FLIGHT CONTROLS - RELOCATION OF THE RUDDER TRIM TRANSDUCER CABLE CONNECTION TO THE RUDDER TRIM CABLE

MODEL	SERIAL NUMBERS
Super King Air B200GT	BY-207, BY-239, BY-250 thru BY-334, BY-336, BY-337
Super King Air B200CGT	BZ-1

MTB-27-01
Page 1 of 2

Figure 1. Rudder Trim Transducer Cable Connection (Sheet 1)

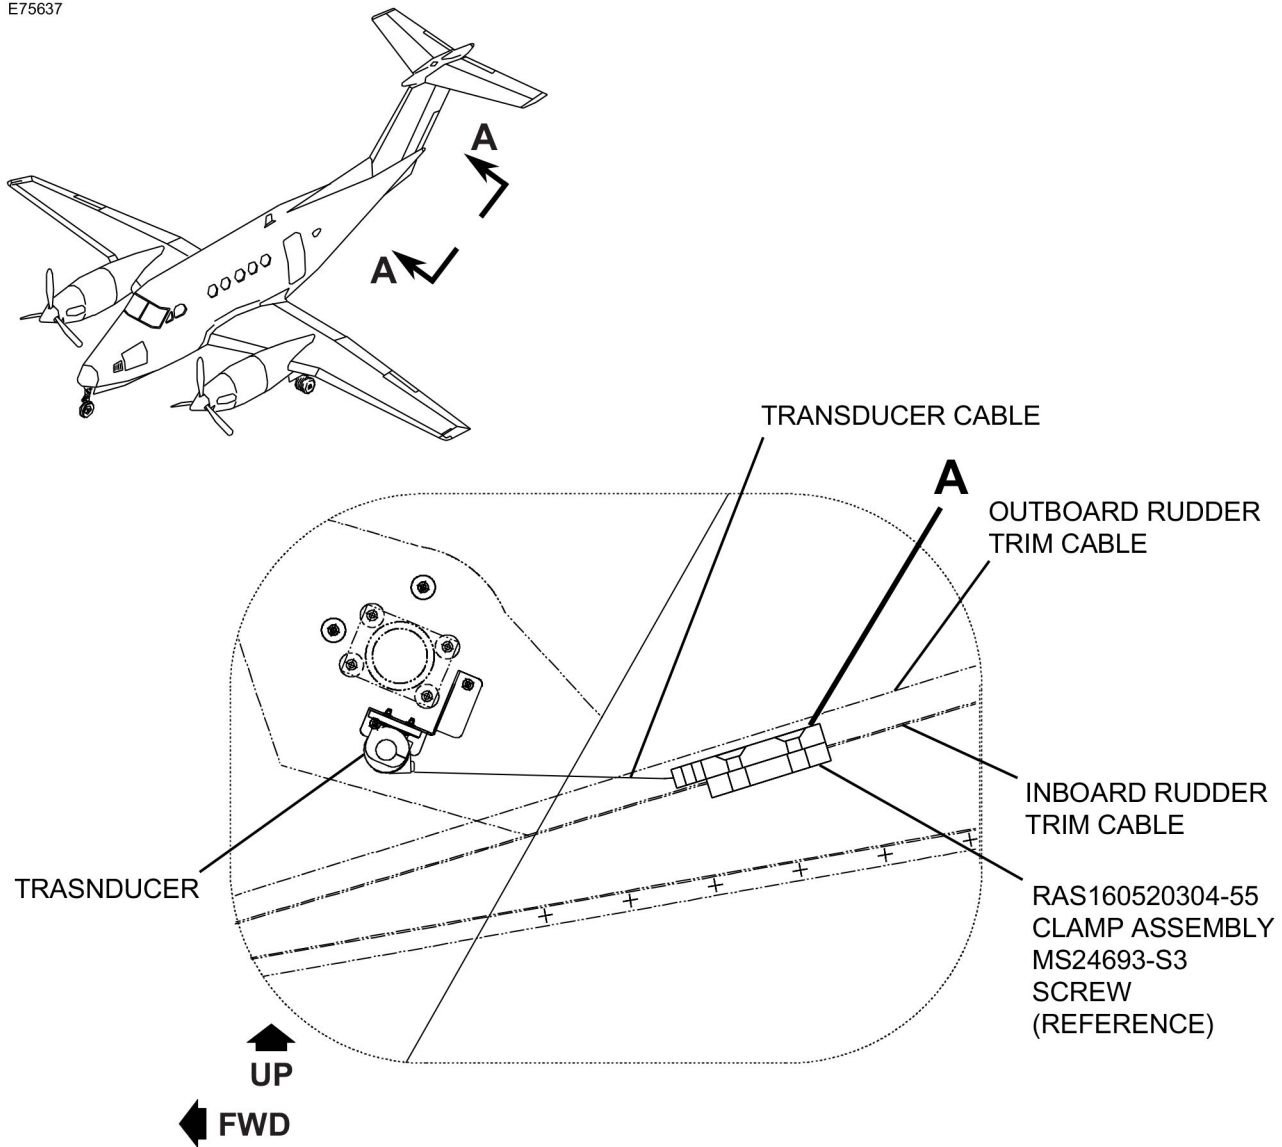
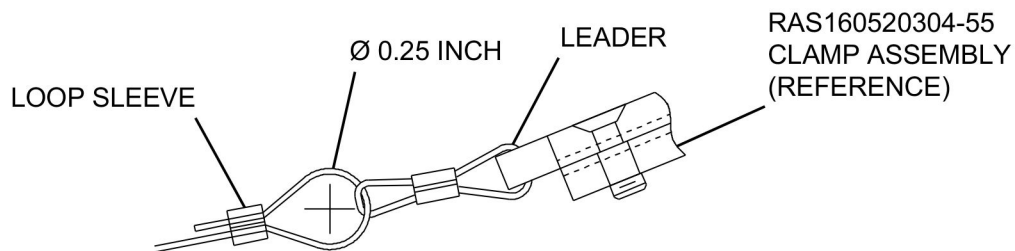
The spring load on the rudder trim transducer can pull on the rudder trim cable, causing movement over time. To reduce its effect, the rudder trim transducer cable and clamp block located on the outboard rudder trim cable, should be relocated to the inboard rudder trim cable.

5. Remove the two MS24693-S3 screws that attach the RAS160520304-55 Clamp Assembly on the outboard rudder trim cable.
 - A. Keep the Screws and Clamp Assembly.
6. Clean all the residue sealants from the screws.
7. Apply Loctite 242 anaerobic adhesive to the threads of the screws.
8. (Refer to Figure 1). Install the kept RAS160520304-55 Clamp Assembly on the inboard rudder trim cable using the kept two MS24693-S3 screws.

9. (Refer to Figure 1). Connect the transducer cable to the clamp assembly on the inboard rudder trim cable as follows:
 - A. Install the leader to the clamp assembly and latch the leader latching mechanism.
